# PLANNING CLEARANCE

GRAND JUNCTION COMMUNITY DEVELOPMENT DEPARTMENT

BLDG ADDRESS 422.5 Prospectors Pt. #16

**► APPROVAL FOR BUILDING PERMIT ◀**  
**Ridges Architectural Control Committee (ACCO)**

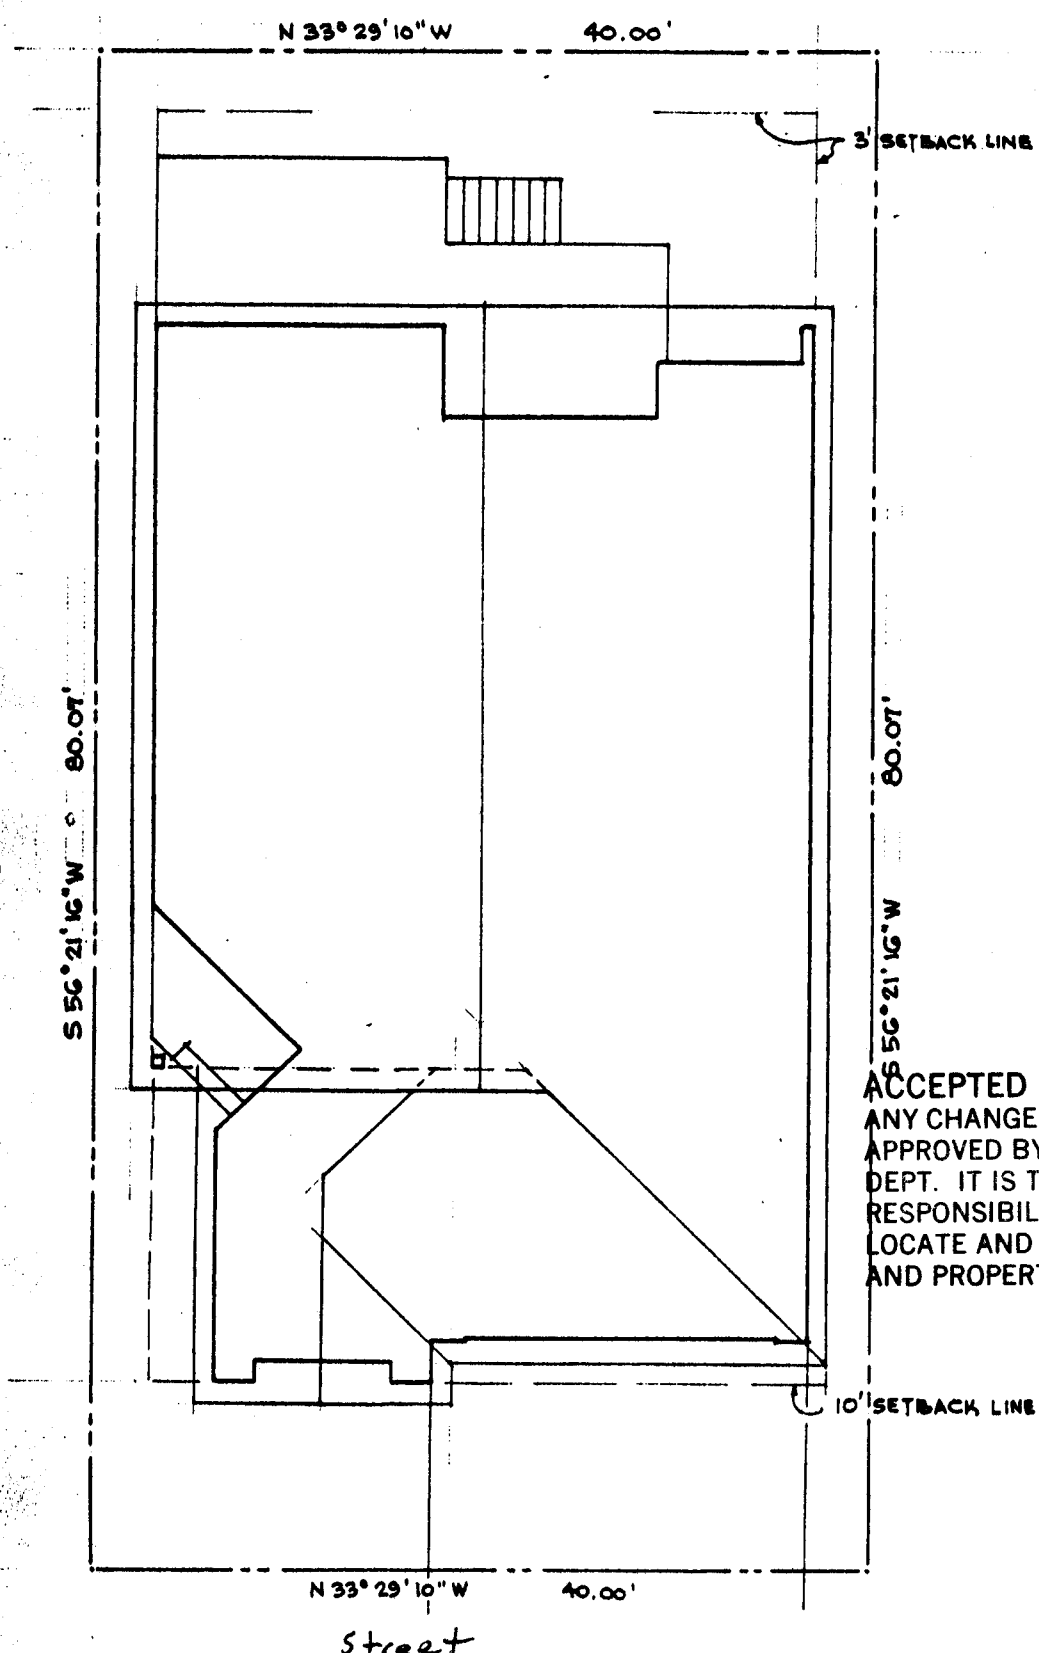
ACCEPTED *MP 10-1-93*  
ANY CHANGE OF SETBACKS MUST BE APPROVED BY THE CITY PLANNING DEPT. IT IS THE APPLICANT'S RESPONSIBILITY TO PROPERLY LOCATE AND IDENTIFY EASEMENTS AND PROPERTY LINES.
